CODE ANALYSIS

15 West Street Proposed Residential Board and Care Portland, ME

June 8, 2017

TITLE:
EXISTING 1st FLOOR PLAN

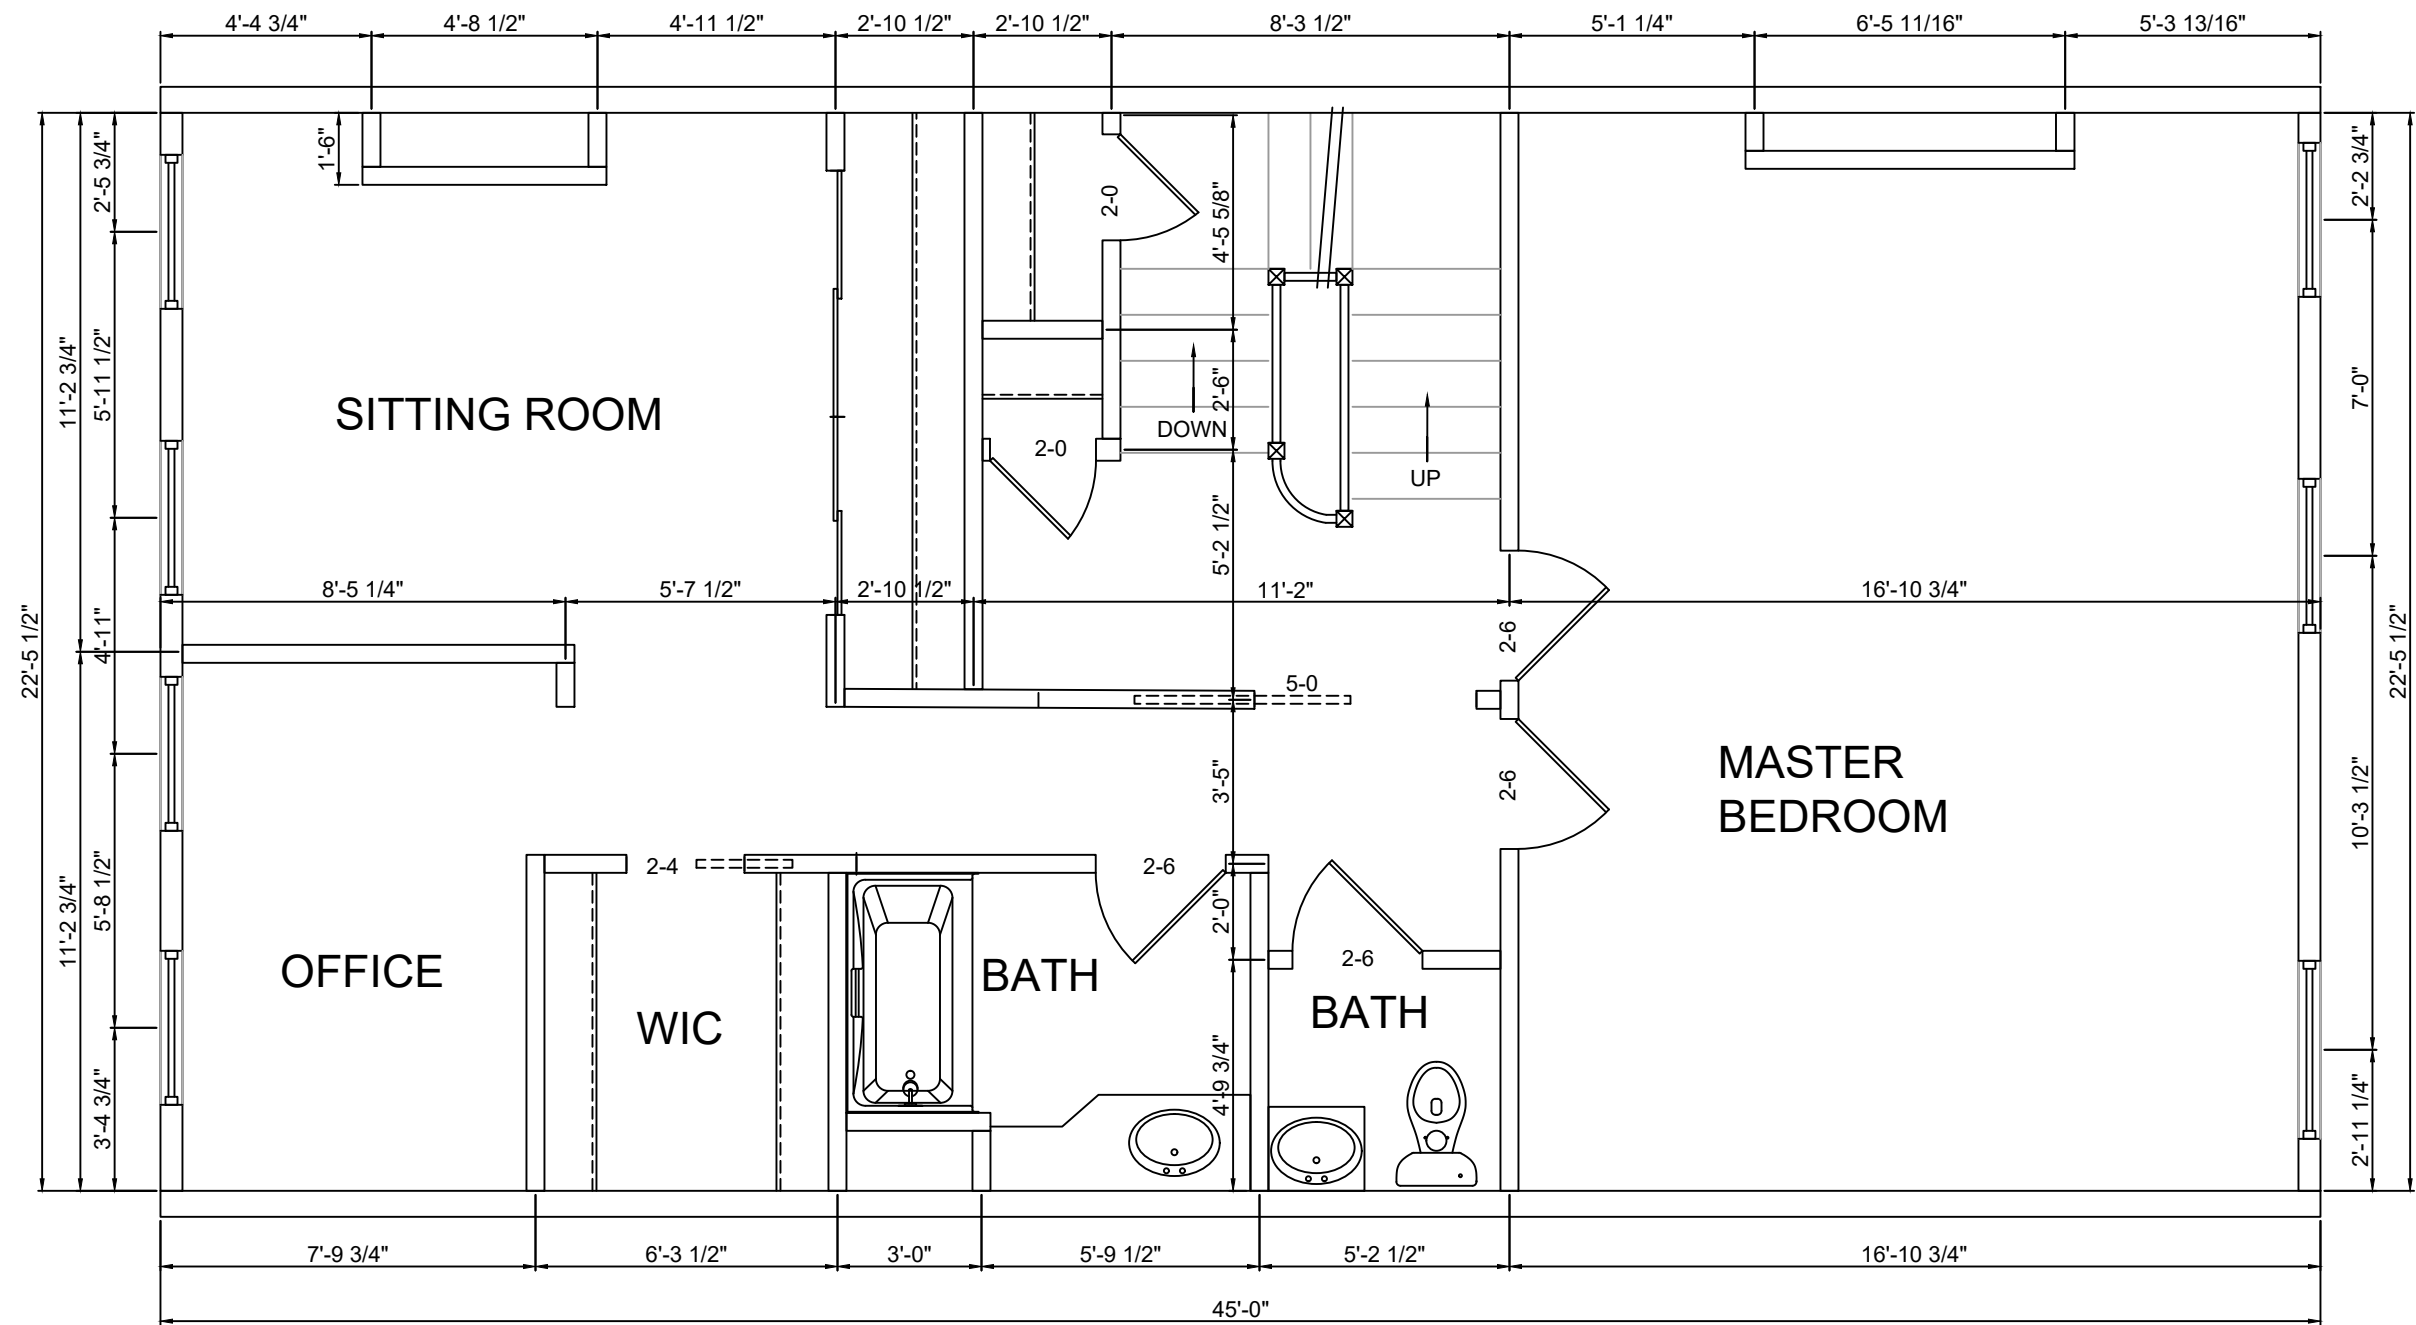
Due to the configuration of the first floor of the subject property, additional automatic closing doors would need to be added at the entrance to the living room and to the dining room, as shown on the attached floor plans (in red). One additional door may be required for floor two (if provisions for automatically closing the existing pocket door are not applied).
